MONTGOMERY COUNTY
BOARD OF COMMISSIONERS

MONTGOMERY COUNTY
PLANNING COMMISSION

Re: MCPC # 24-0254-003
Plan Name: Wawa Proposed Fly Thru Conditional Use
(1 lot comprising approximately 4 acres)
Situate: 1145 Virginia Drive (cross street: Office Center Drive)
Upper Dublin Township

Concept Sketch to Reduce Ped./Veh. Conflicts

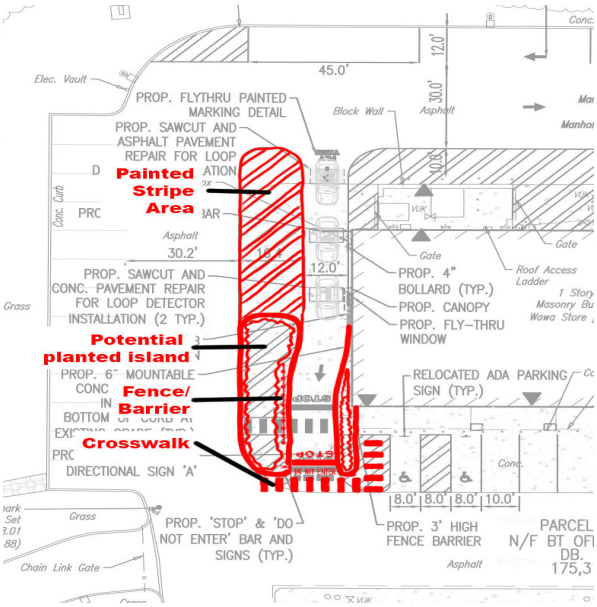
A pedestrian crosswalk is provided across the fly-thru lane, however, in its current design the crosswalk and dual stop bars create a pedestrian and vehicle conflict. Two stop signs and stop bars surround the crosswalk and do not provide the necessary distance for one stopped vehicle behind the stop bar at the exit of the fly-thru lane. The rear of a vehicle will overhang the crosswalk while waiting to exit the fly-thru lane. We recommend that the applicant adjust the site plan to reduce vehicular and pedestrian conflicts caused by the multiple stop bars in the fly-thru lane. Physical barriers such as landscaping and visually permeable fencing may be warranted to direct pedestrians around this conflict. As an example, below is an aerial image of a building with a drive-through in Langhorne, Bucks County. A concept sketch of how this could be implemented is also included below.

TITLE: SITE PLAN

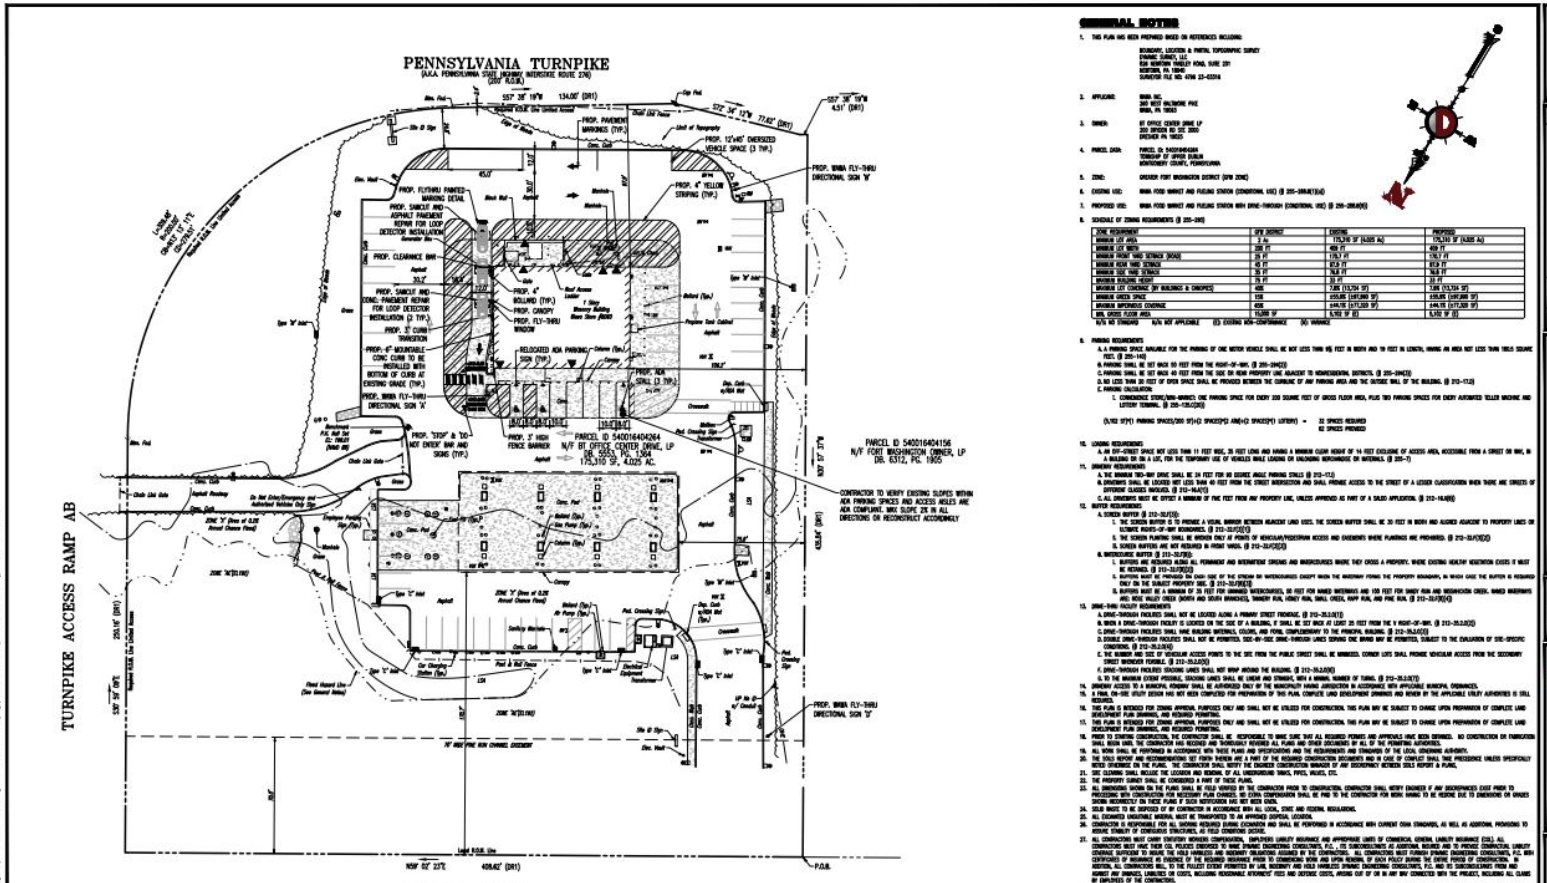
1. *Proximity to Loading Zone*. Based on the new plans provided, the loading zone has been revised and expanded to remove the larger queuing lane as it was shown on the previous plan set dated July 15, 2024. While the queueing lane has been removed in the current plans, it has also been significantly reduced in size. Removing the formal queuing lane and expanding the loading zone striping may help alleviate potential vehicular conflicts. However, the township may want the applicant to confirm if the current three space queuing is adequate for the amount of potential fly-thru traffic quantities.

B. Pedestrian Circulation. According to § 255-295.E(7) - (b) Parking and areas shall be designed so as to ensure the safe, orderly and efficient movement and use of the site by both motorists and pedestrians; (c) Conflicts between vehicular and pedestrian movements shall be minimized to the greatest extent practical; and (d) Landscaping and pedestrian pathways shall be installed and maintained in all parking areas. Solutions such as changing the materials, color and texture of parking areas, driving lanes and pedestrian routes shall be utilized to clearly define and differentiate the vehicular and pedestrian circulation patterns and pathways.

A. Bike Facilities. There is an adjacent multi-use trail constructed on the northern side of Virginia Drive. The reconfiguration of the site with a fly-thru lane provides an opportunity to improve the site for trial users. Bicyclist trail users may want to stop at this Wawa for a break or to grab snacks or drinks. There are currently no bicycle racks on the property to accommodate these trail users. We recommend the addition of bicycle racks to accommodate trail users.
